May 26, 2014

RE: Alternatives for Eliminating the \$80M SVC as an Integral part of the PHI/Exelon
500kV Red Lion – Salem Proposal to Solve the Artificial Island Stability Problem

Figure 1. Salem Generator Stability Plots for a 2% Neutral Reactor installed at the Salem GSUs

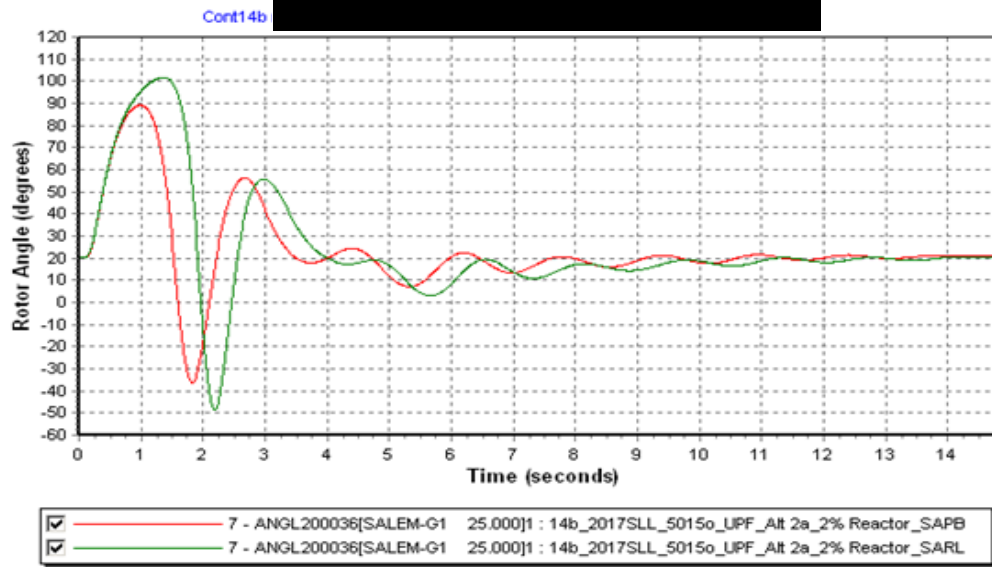
Figure 1 presents the stability plots from installing a 2% neutral reactor to the two Salem GSUs for both the proposed Peach Bottom –Salem (PB-S) (in Red) and RL-S (in Green) lines. Figure 2 presents the stability plots from installing a 1% neutral reactor to

the two Salem GSUs and the Hope Creek GSU. As shown in these plots, the AI system with the addition of either the proposed PB-S or RL-S line will maintain stability for the 10.14 cycles delay clearance without the need of the SVC. We are providing the idev files for your staff to verify our results.

Figure 3. Salem Generator Stability Plots for the back-to-back circuit breaker scheme with an 8-cycle delayed clearing time

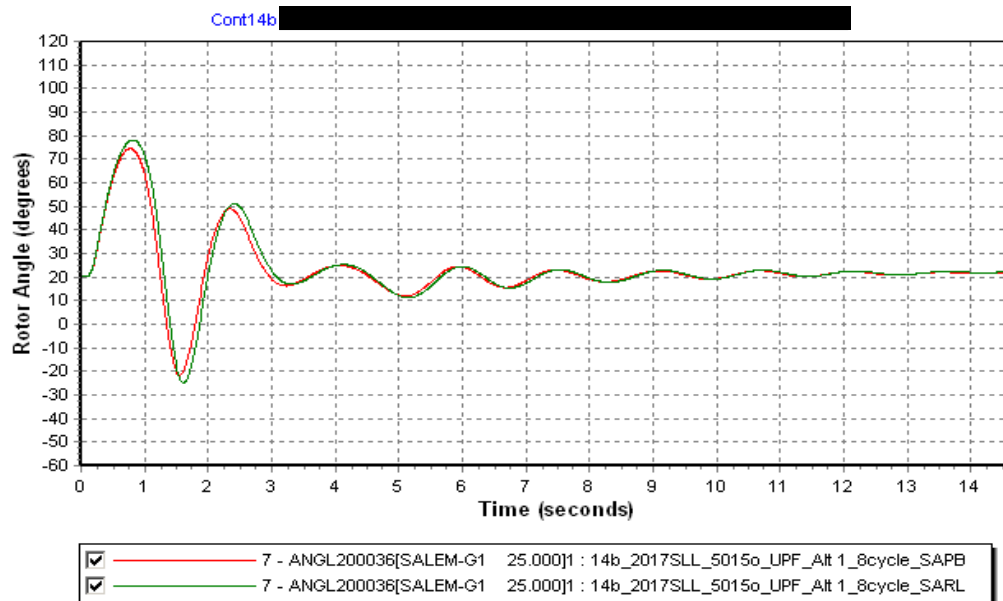
Figure 3 presents the stability results of employing a back-to-back circuit breaker scheme to interconnect the PHI/Exelon proposed line to the Salem Substation. The delayed clearance time was set to be at 8 cycles, a 2.14 cycle reduction from the 10.14 cycles delayed clearing time of the existing Salem circuit breakers. No SVC is included in the simulation. As shown in the figure, the AI system maintains stability without a SVC. We are also providing the idev file for your staffs to verify our results.
